Thank you for the opportunity to review the **First (1st)** Traffic Impact Study (TIS) prepared by **Galloway & Company Inc**, dated September 8, 2025 (received on September 17, 2025), for the proposed **Strathmore Street Apartments (SHA Project No. 25APMO040XX)** located on **MD-355** at Mile point **1.36** in **Montgomery County**, Maryland.

RE: 7025 Strathmore Street Apartments, Use of Alley as Primary Access

RE: Preliminary Plan No. 120250120
7025 Strathmore
Preliminary Plan & Traffic Impact
Study (TIS) Letter
Revised Letter

FIRE ACCESS PLAN

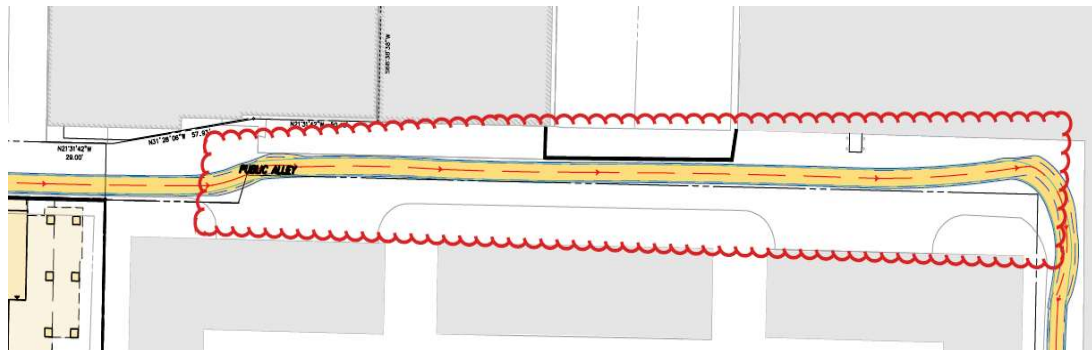
- i. Based on the turning templates for the passenger cars as shown below, the passenger car is still encroaching into the 9-foot section of the property, which is

outside the public dedication, and is using the approach lane, which is a traffic safety concern. The applicant must provide an acceptable statement confirming their right to use the 9-foot area.

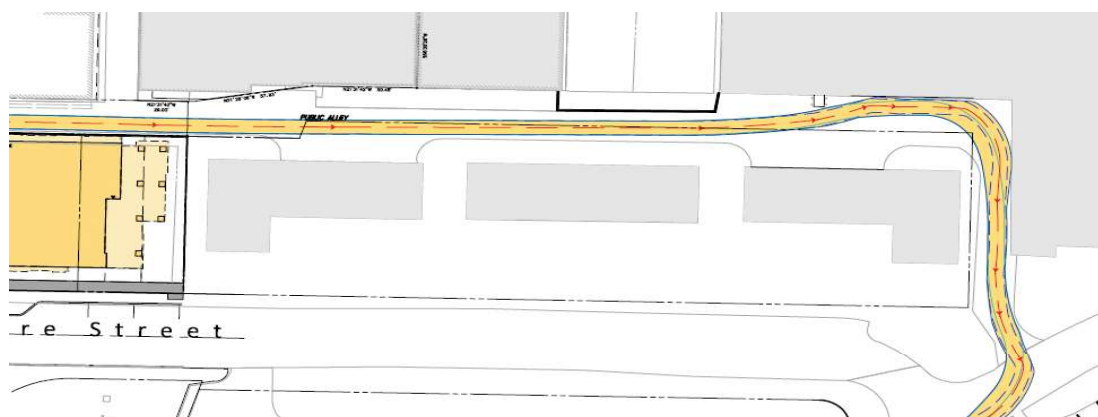
- ii. Based on the turning templates shown below, the vehicle (SU-30) encroaches into the 9-foot section of the property, which is outside the public dedication. The vehicle encroachment into the opposing traffic lanes must be minimized to the maximum extent possible at the 90-degree bend in the alley. The applicant must provide an acceptable statement confirming their right to use the 9-foot area.

FIGURE 5-1
Proposed Off-Site Mitigation Improvements

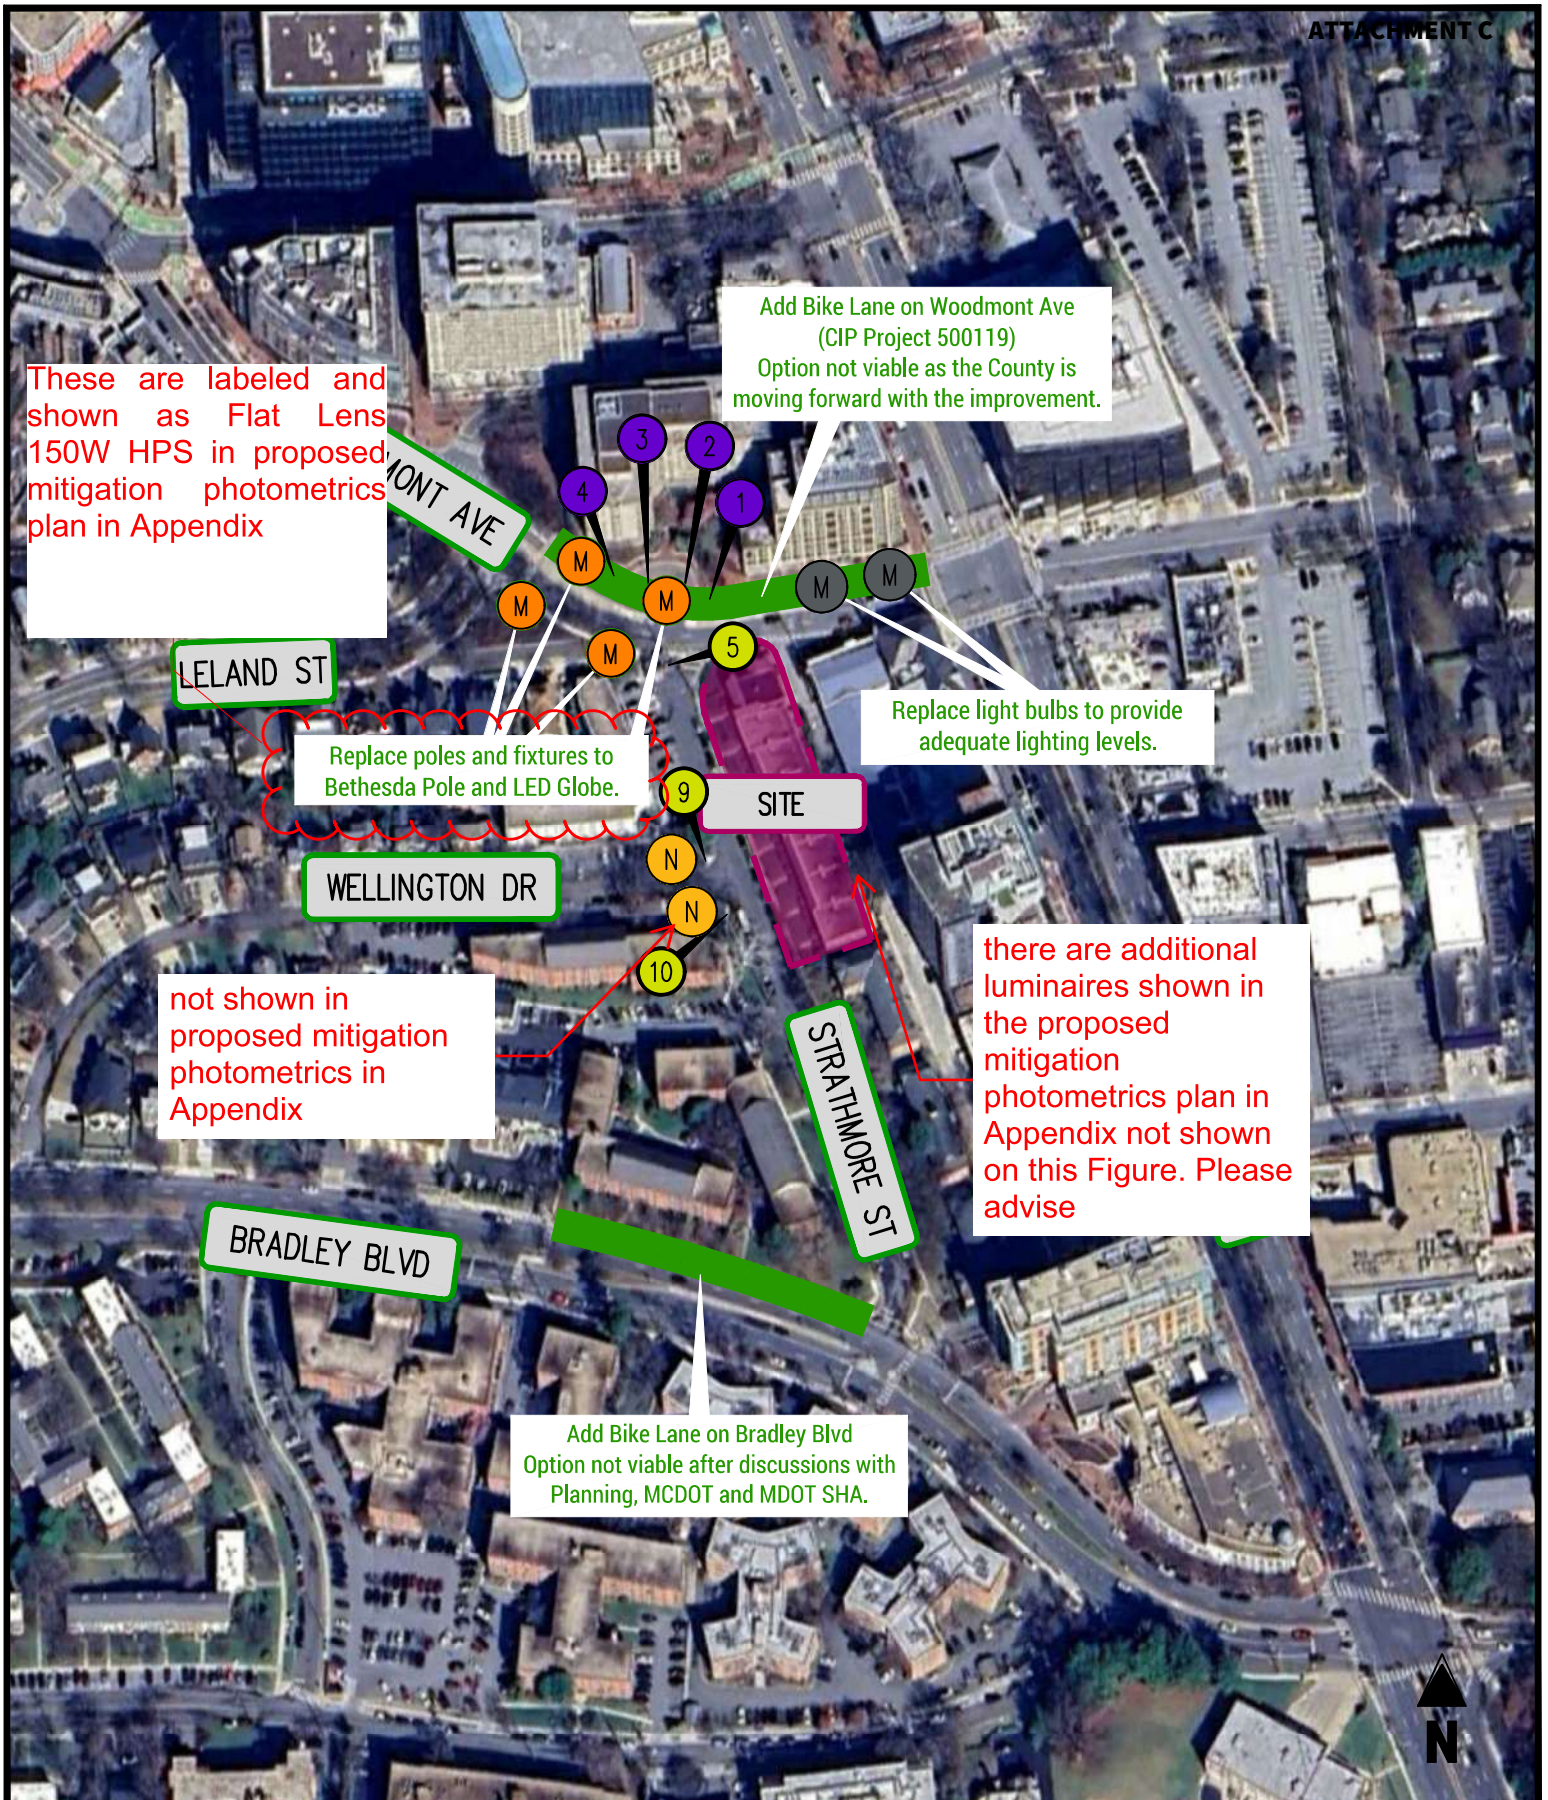
- a. ADA Curb Ramp: As per Table 5-1 and Figure 5-1 of the LATR, the following improvements will be constructed by the applicant:
 - i. NE outside corner Pick-up/Drop-off for Crescent Plaza Condominium.

- b. Street Light Improvements: The following improvements will be constructed by the applicant:
 - i. Replace light bulbs at two locations to provide adequate lighting on Woodmont Avenue closer to the intersection with Wisconsin Avenue, as shown in Figure 5-1 and Table 5-1 of the LATR.

- ii. Replace light poles and fixtures with Bethesda Poles and LED Globes at four locations to provide adequate lighting on Woodmont Avenue, as shown in Figure 5-1 and Table 5-1 of the LATR.

- iii. Add two new Bethesda poles and LED globes on Wellington Drive near the intersection of Strathmore Avenue, as shown in Figure 5-1 and Table 5-1 of the LATR.

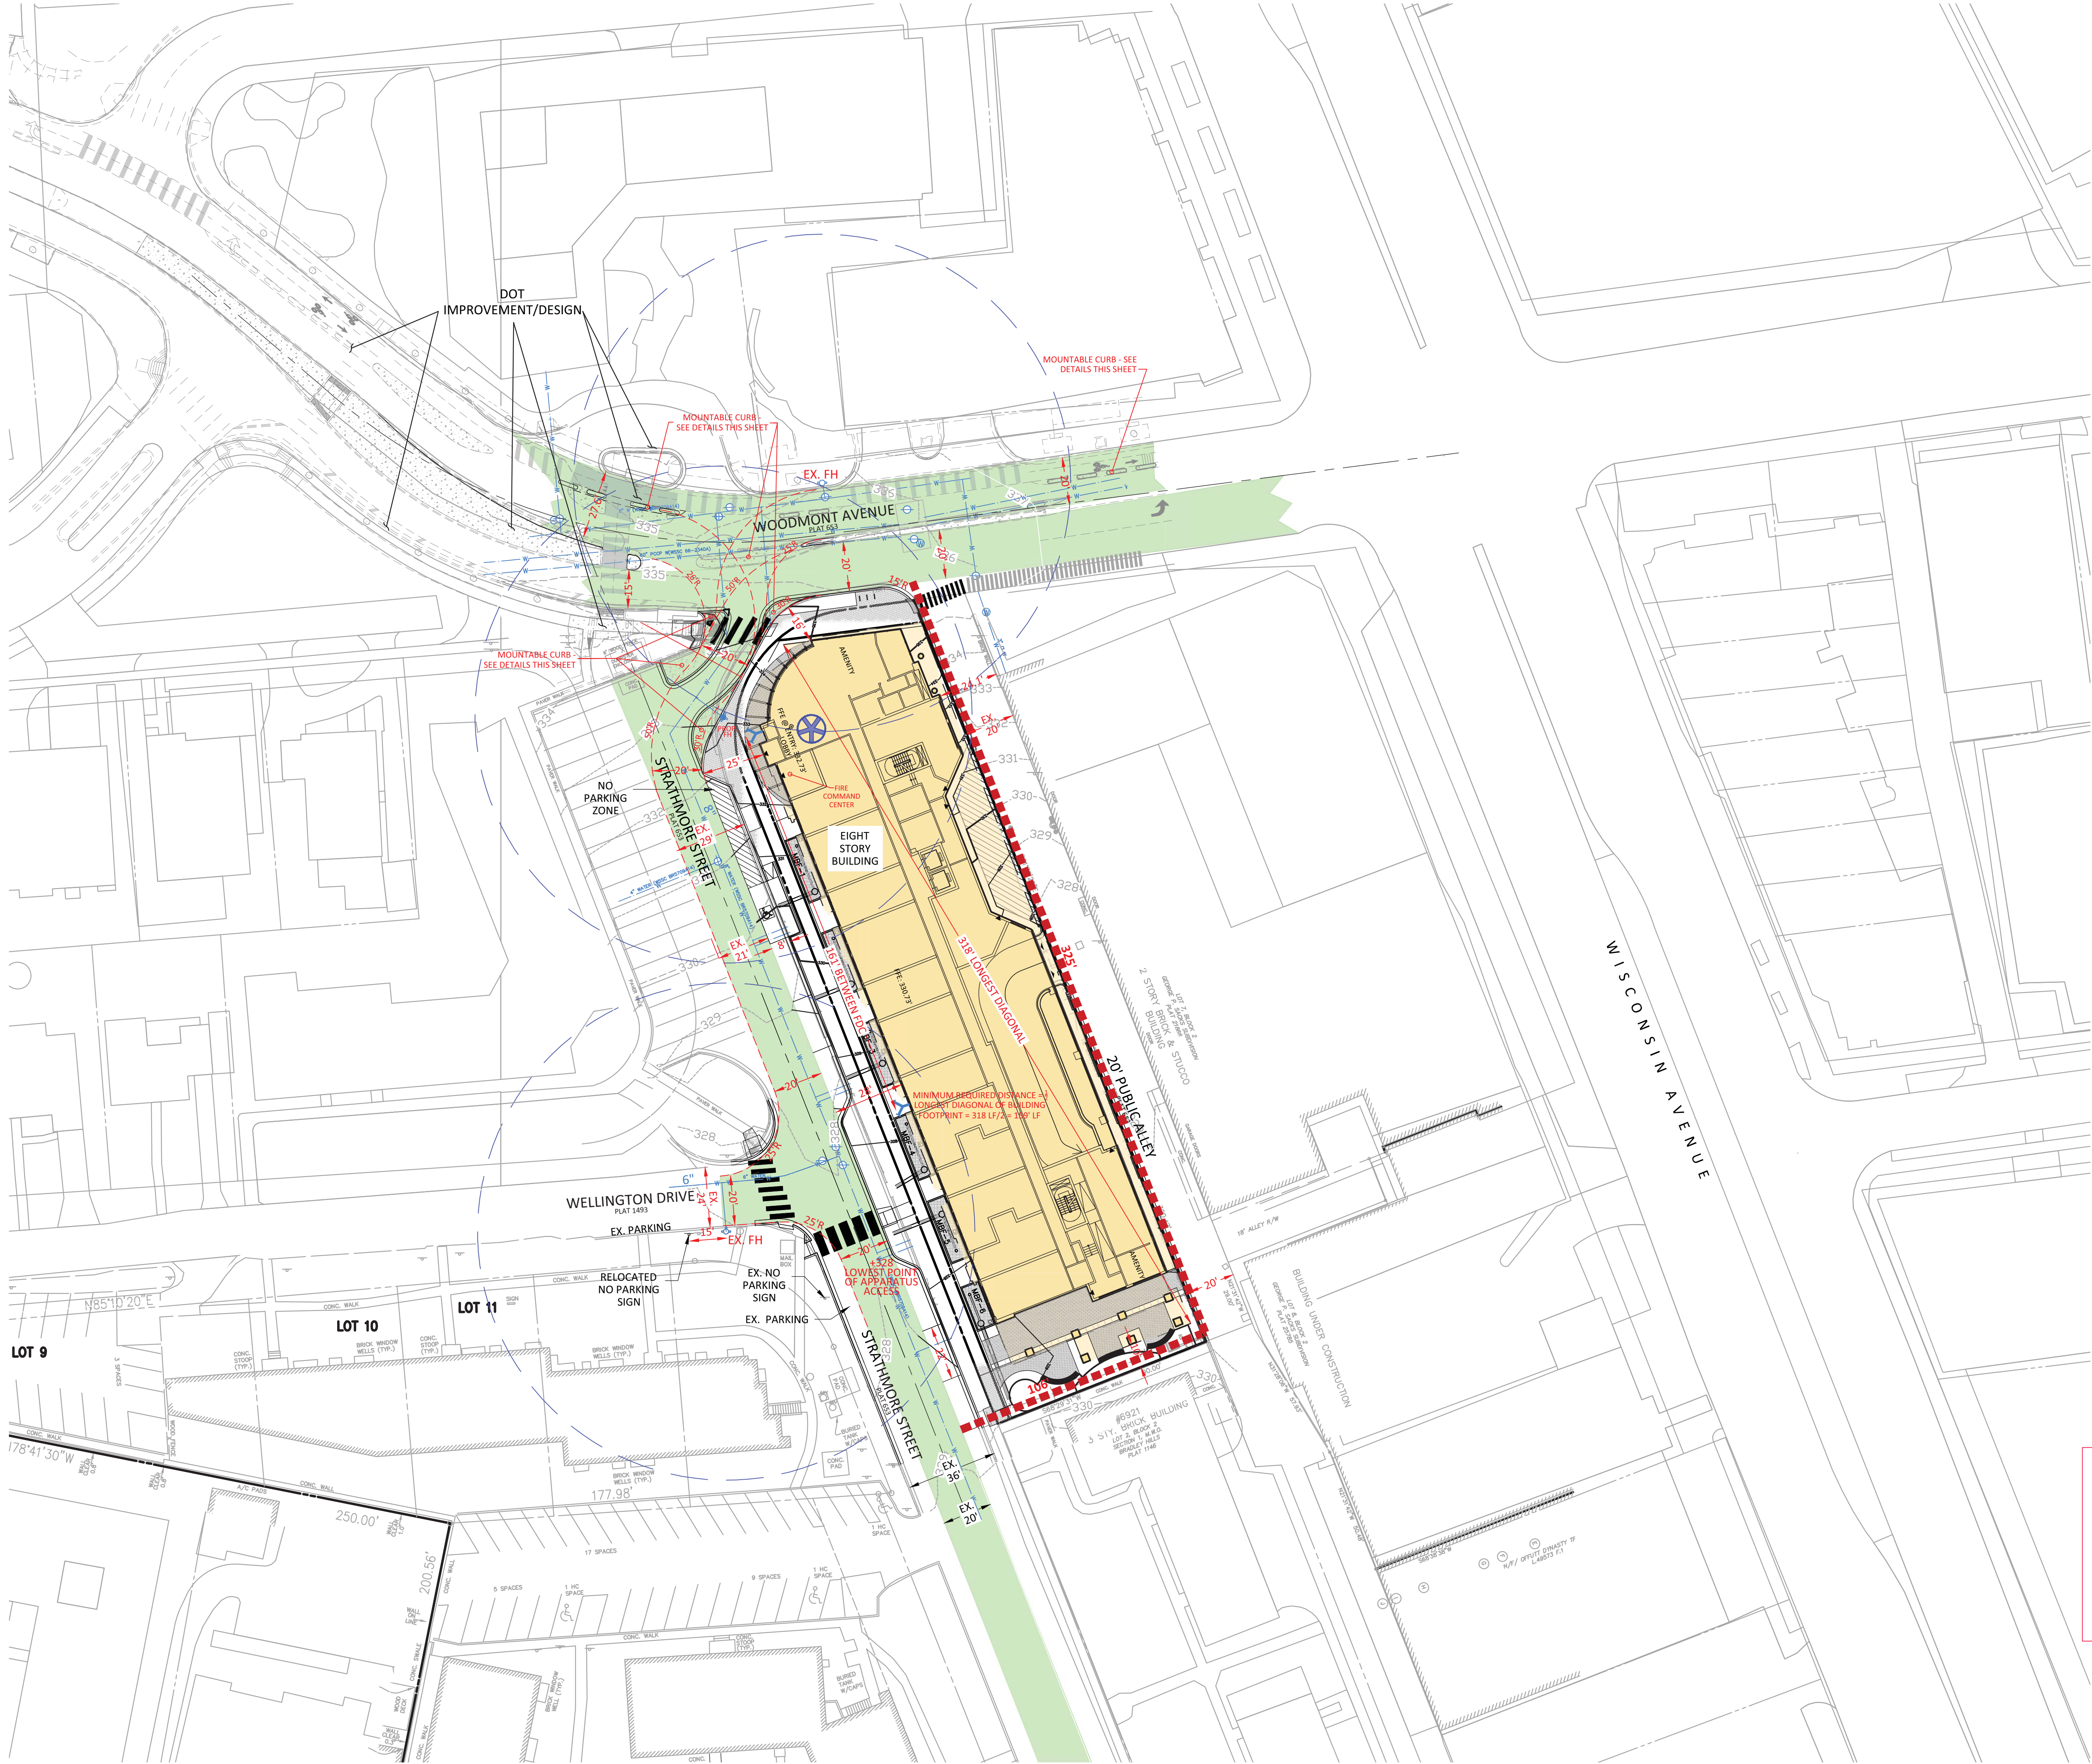
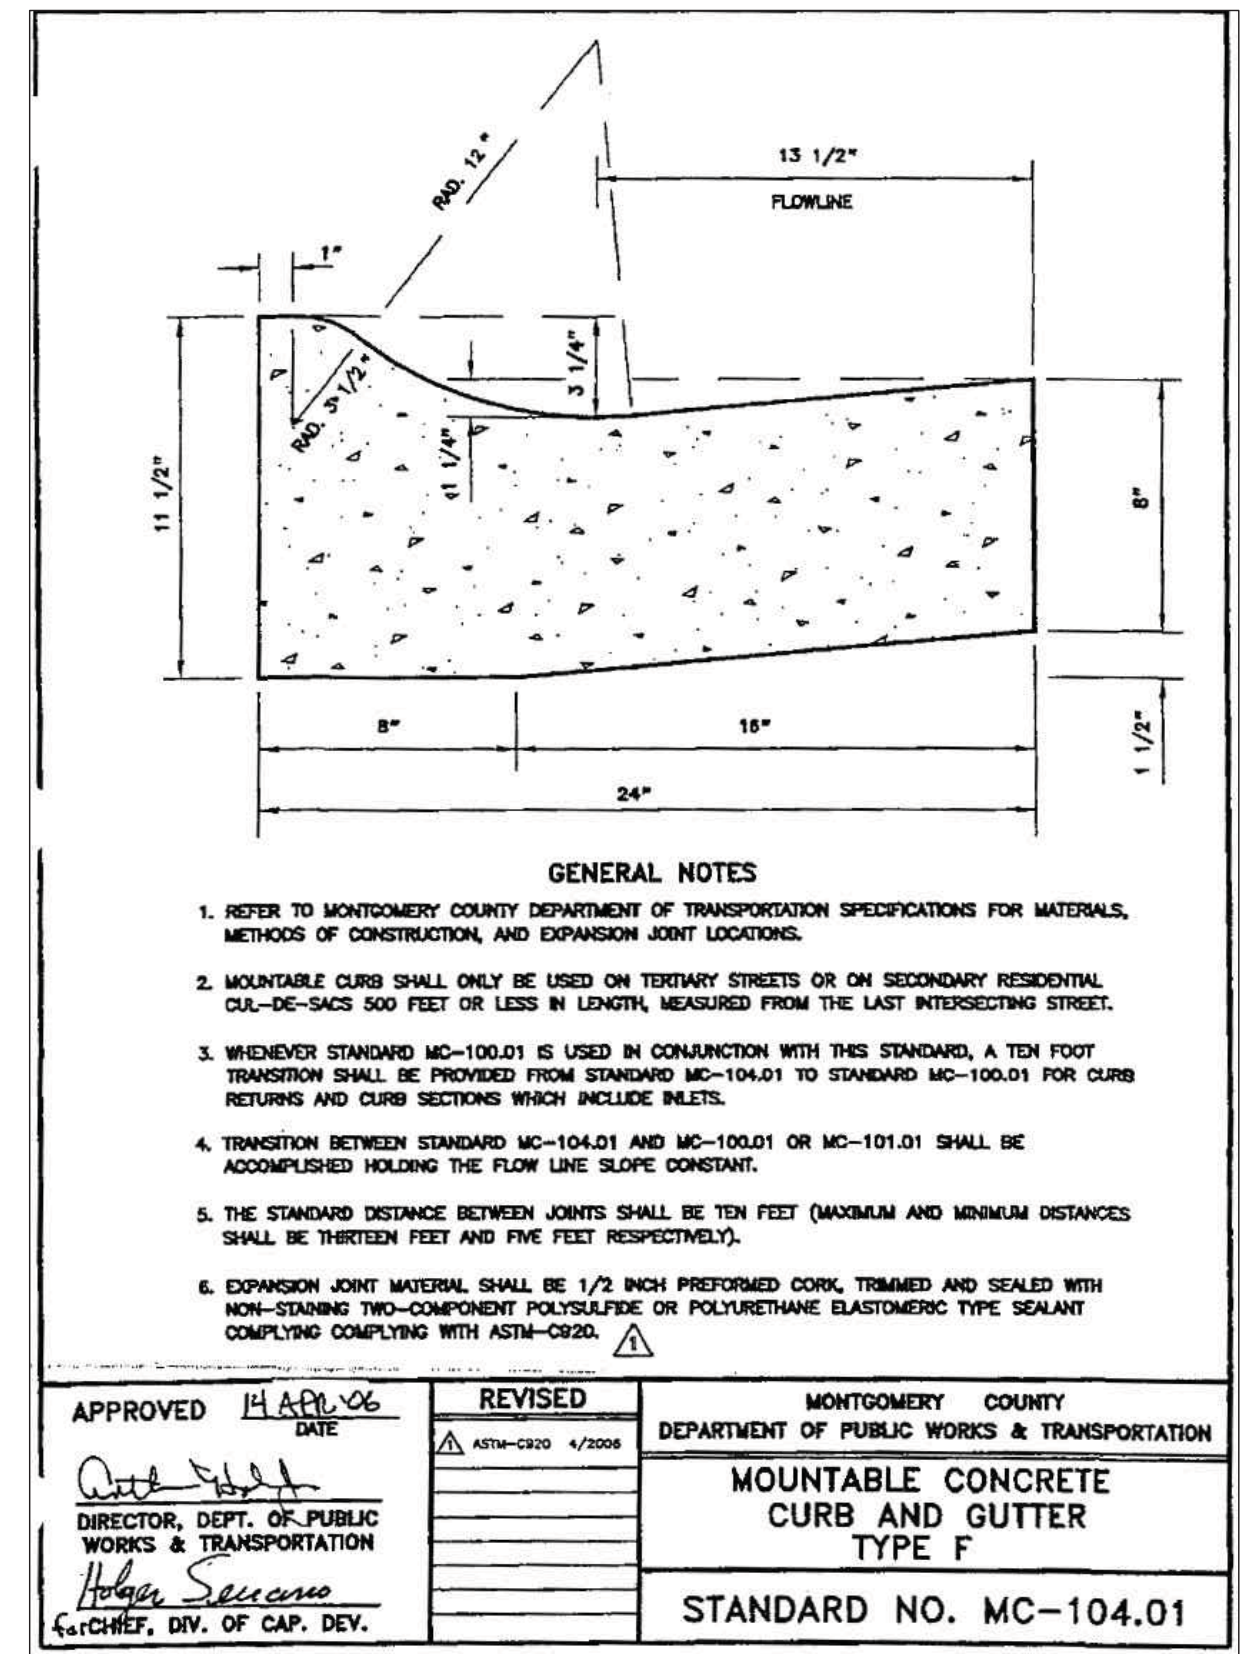
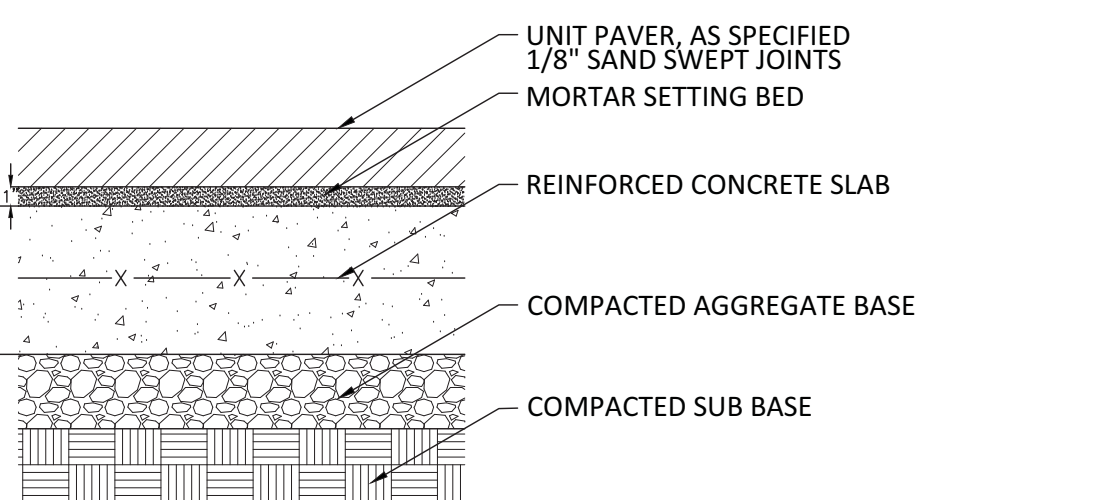
1. Review based only upon information contained on the plan submitted **22-Jul-25** .Review and approval does not cover unsatisfactory installation resulting from errors, omissions, or failure to clearly indicate conditions on this plan.
2. Correction of unsatisfactory installation will be required upon inspection and service of notice of violation to a party responsible for the property.

***** See plan for truck apron details *****

*** All fire department vehicular access surfaces and subgrades shall meet minimum MCDOT tertiary road load bearing capacity ***
